Project: **Brick Breeden Fieldhouse – West Entrance Roof Retrofit PPA #19-0172**
Montana State University – Bozeman, Montana

ENGINEER: DCI Engineers
TO: All plan holders of record

MSU Brick Breeden Fieldhouse West Entrance Roof Retrofit

MEP ADDENDUM #1

SHEET
S2.1

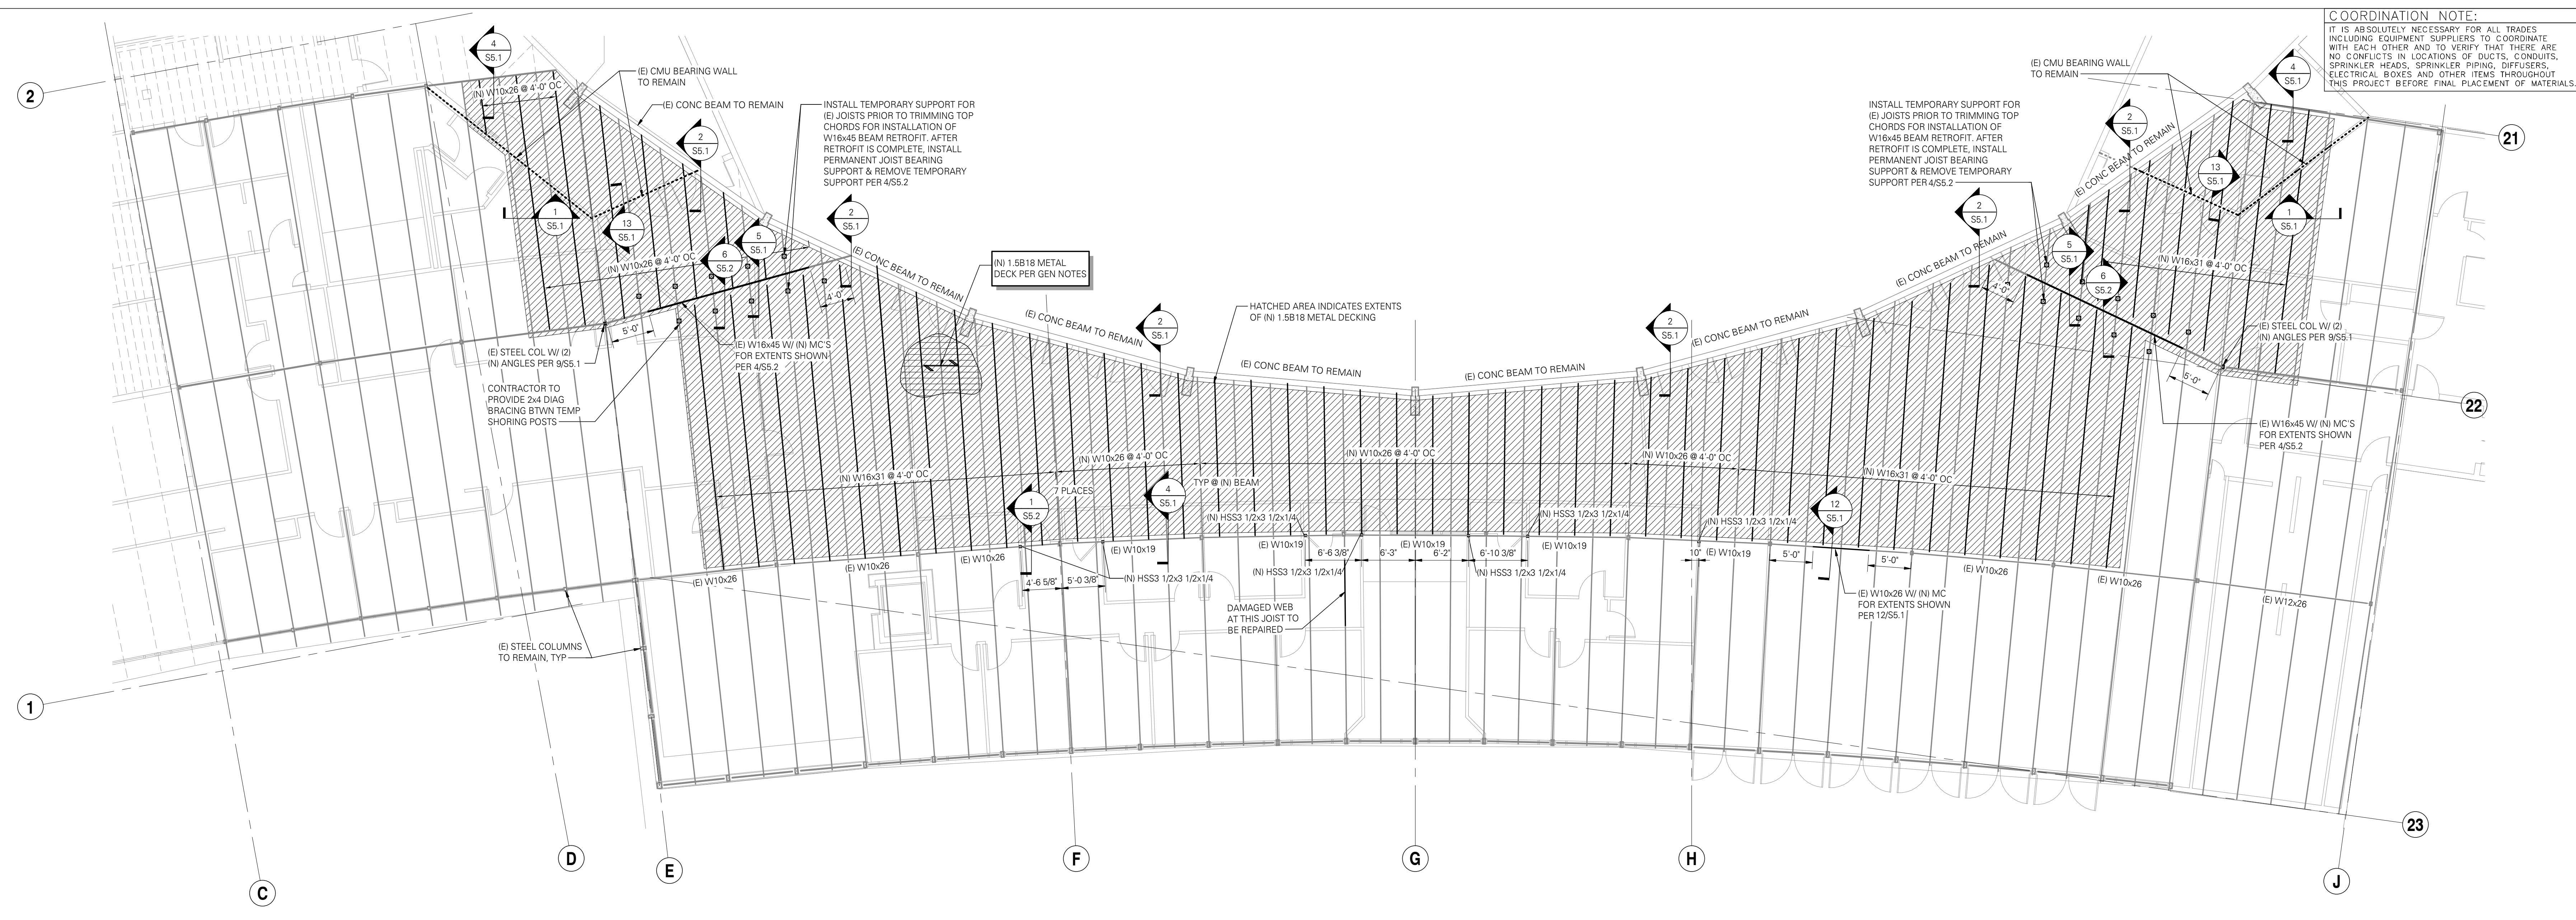
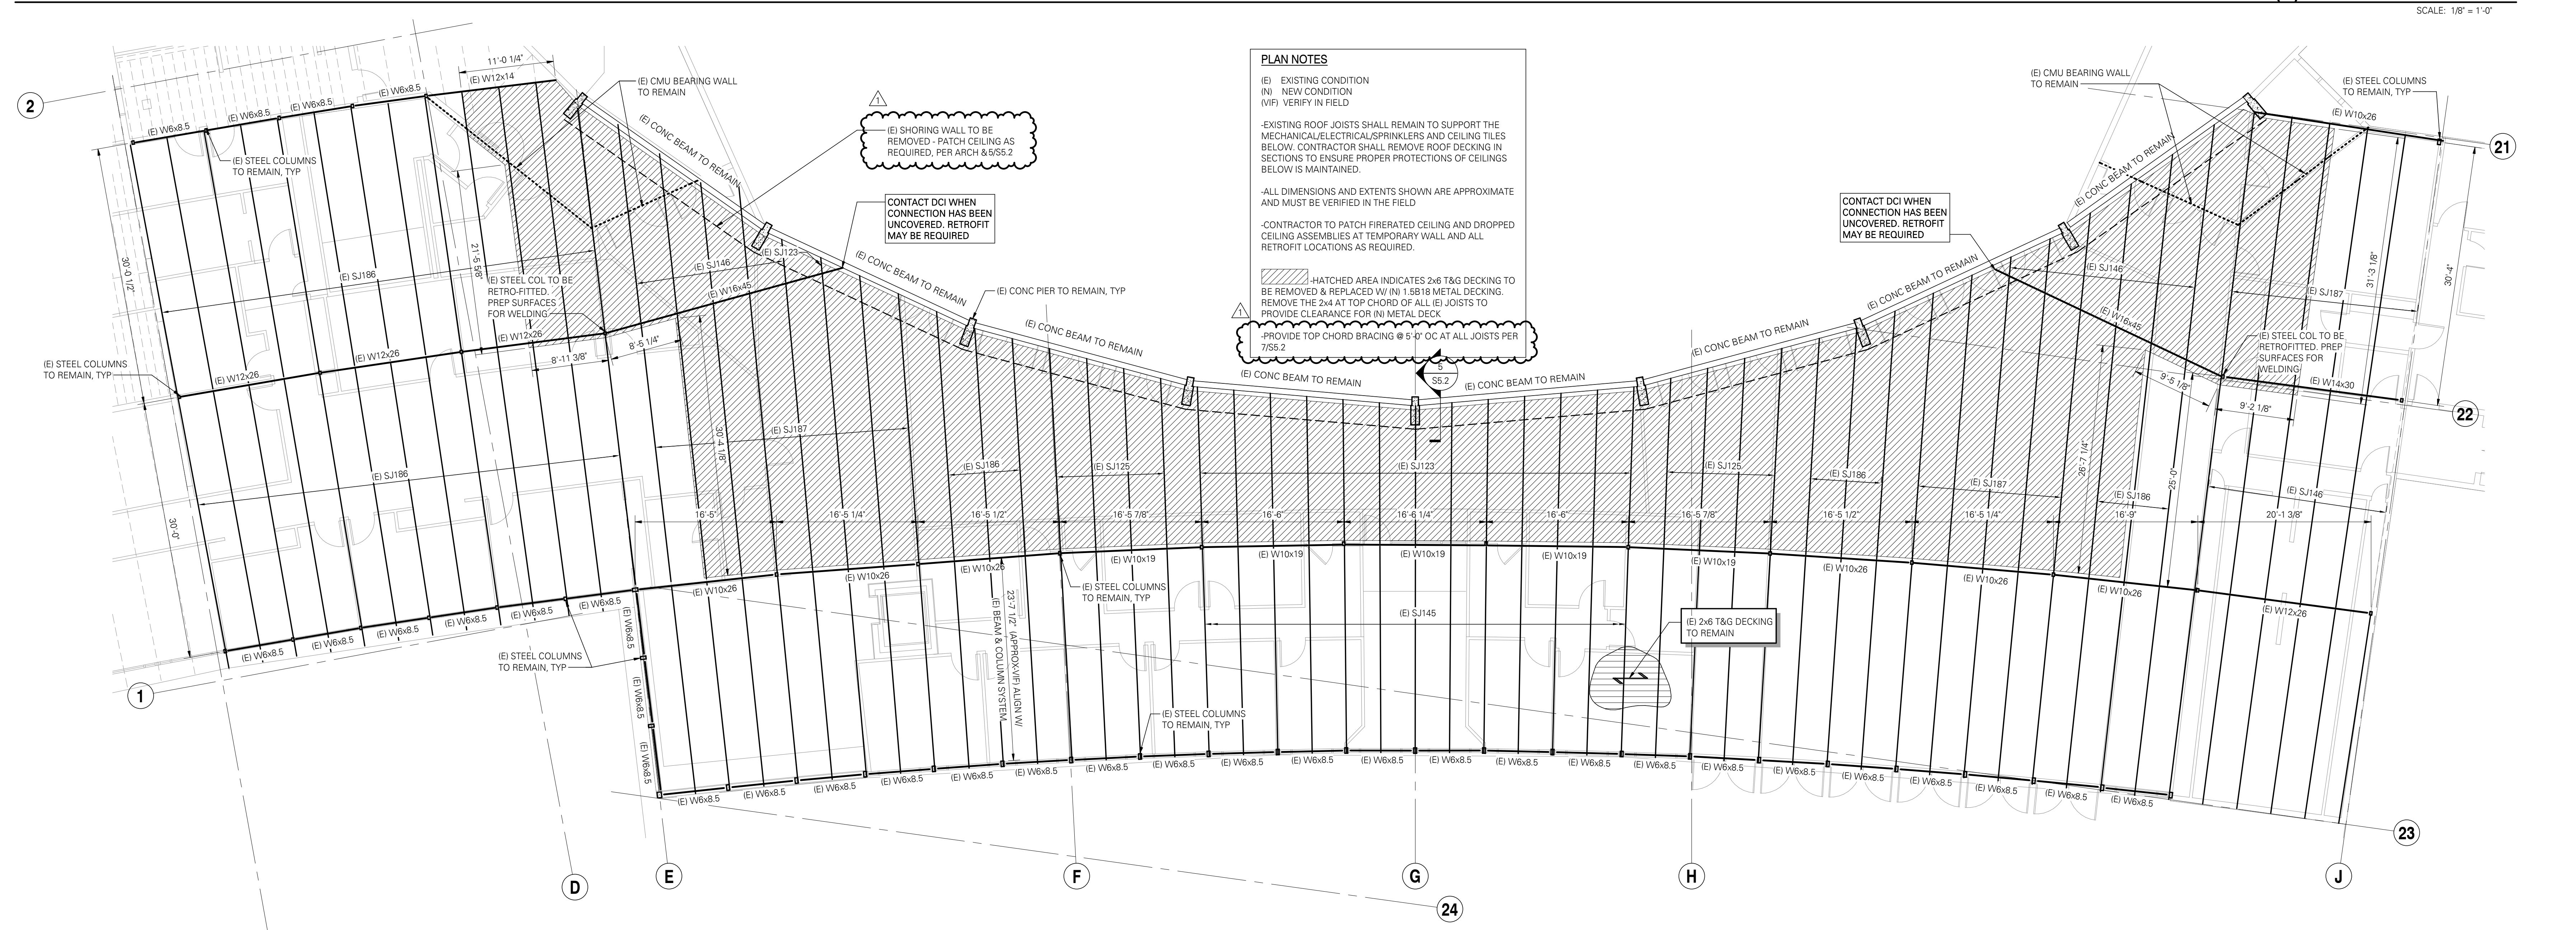
- Revised note for removal of shoring wall; the wall does not need to remain until construction is complete and can be removed at any time once construction has commenced at the discretion of the contractor.

2 (N) W-BEAM AT (E) CONCRETE BEAM
SCALE: 1" = 1'-0"

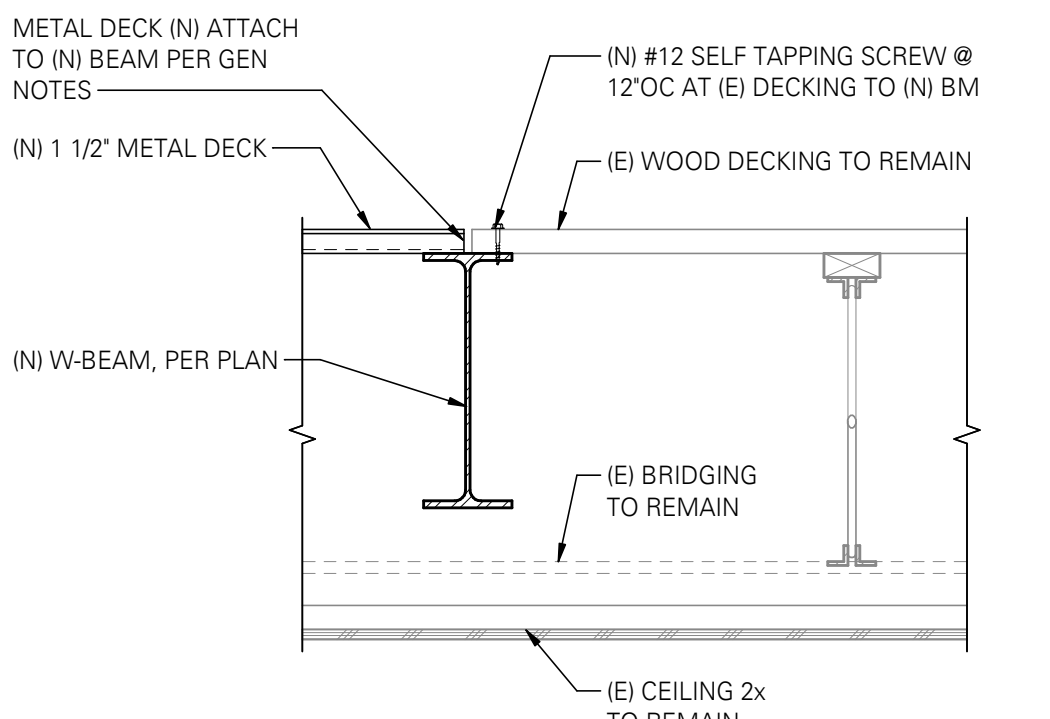
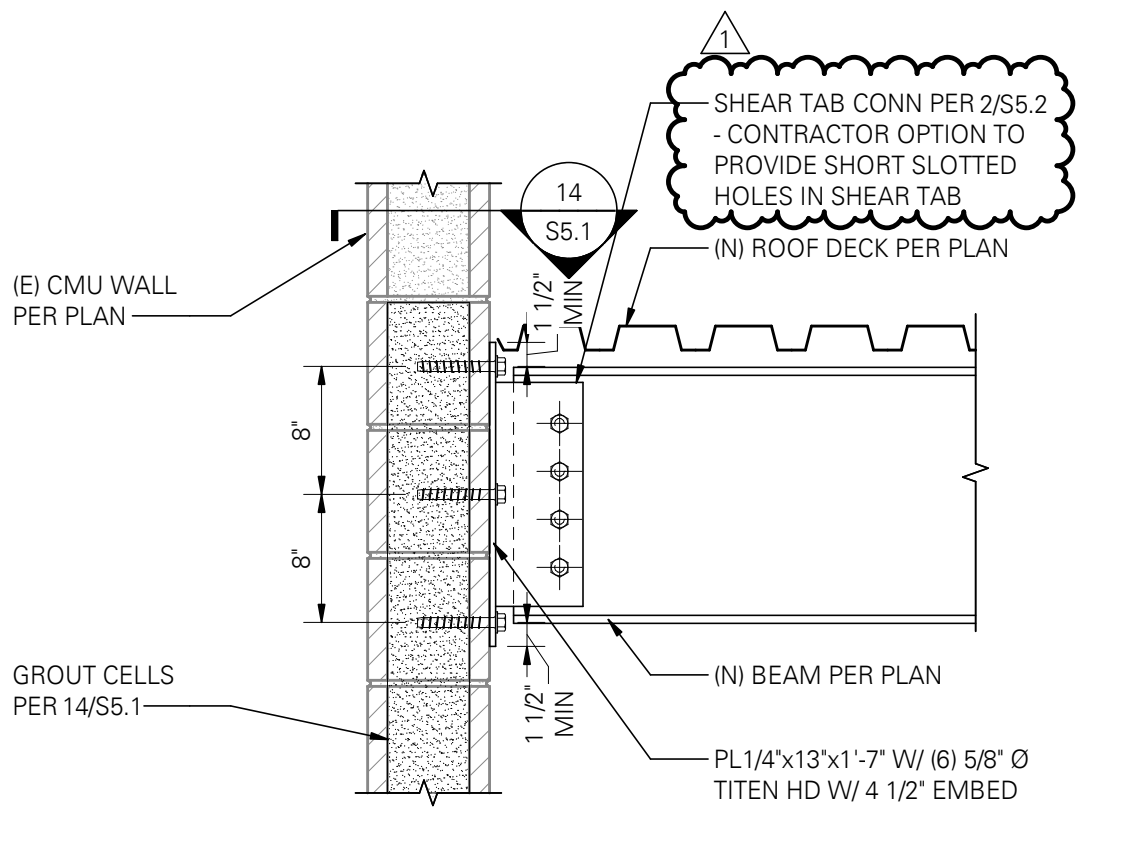
- **2/S5.1:** Added contractor options for connection of new steel beam at the existing concrete beam. Revised note regarding shoring wall removal.
- **3/S5.1:** Added contractor options for connection of new steel beam at the existing concrete beam.
- **4/S5.1:** Added contractor options for field weld connection of new steel beam at existing steel beam.
- **13/S5.1:** Added contractor option for short-slotted holes in shear tab.
- **16/S5.1:** Added new detail showing welded shear tab connection as an option for detail 2/S5.1.

5 (E) SHORING WALL TO BE REMOVED
SCALE: 3/4" = 1'-0"

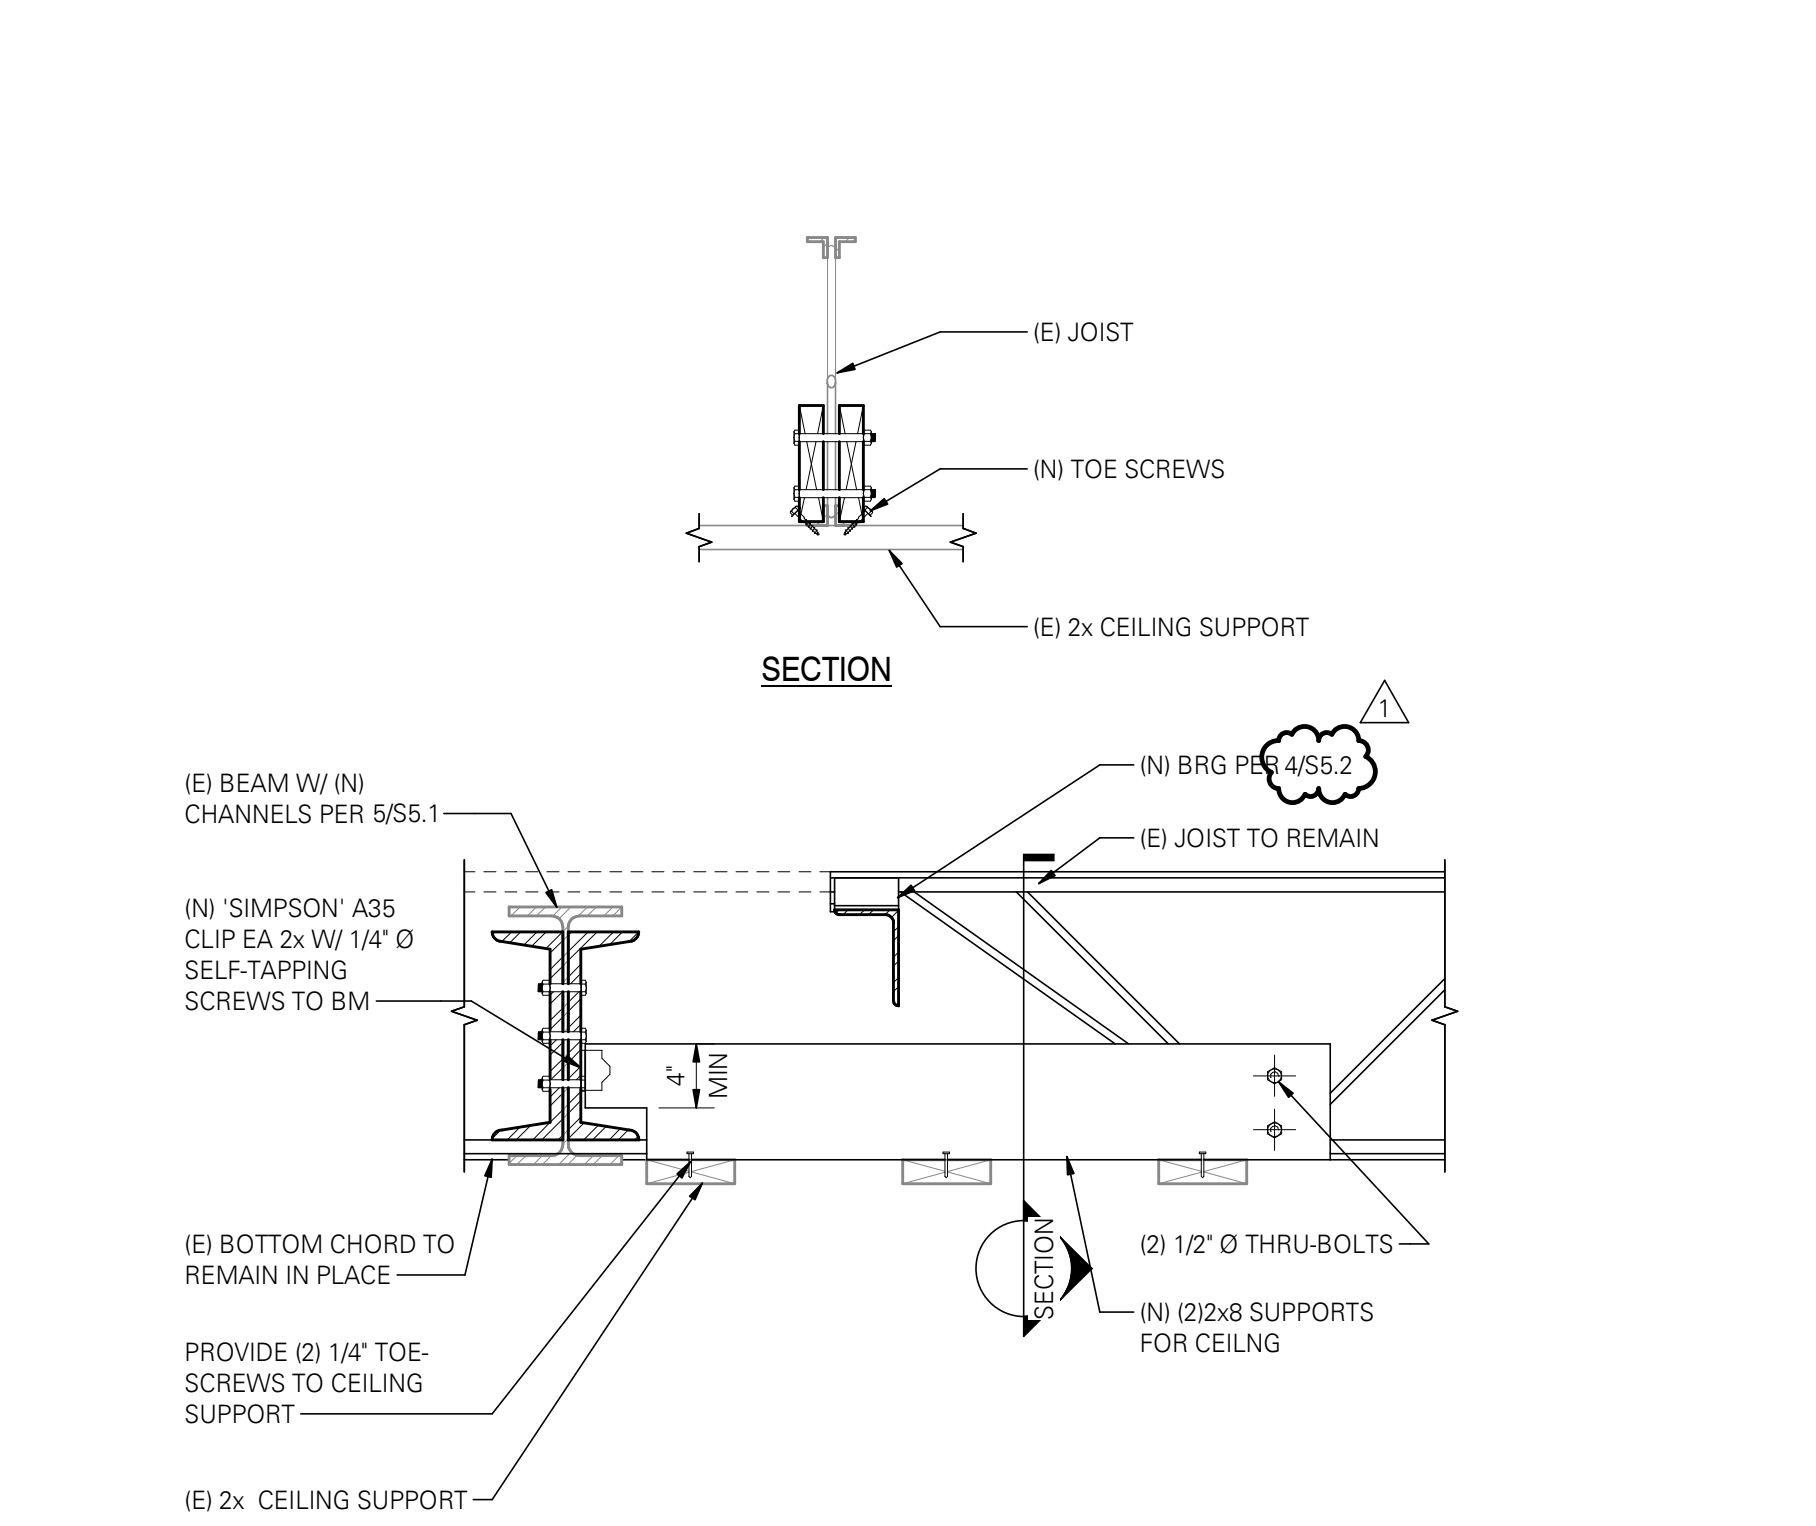
- **5/S5.2:** Revised note regarding when the shoring wall may be removed, it can be removed at any time at the discretion of the contractor.
- **6/S5.2:** Revised reference detail to be 4/S5.2 at joist bearing in lieu of 2/S5.2.
- **7/S5.2:** Added new detail showing top chord bracing to be installed at existing joists following removal of the 2x roof decking and 2x4 top chord nailer. This is typical at all existing joists where the new structural beams are installed.
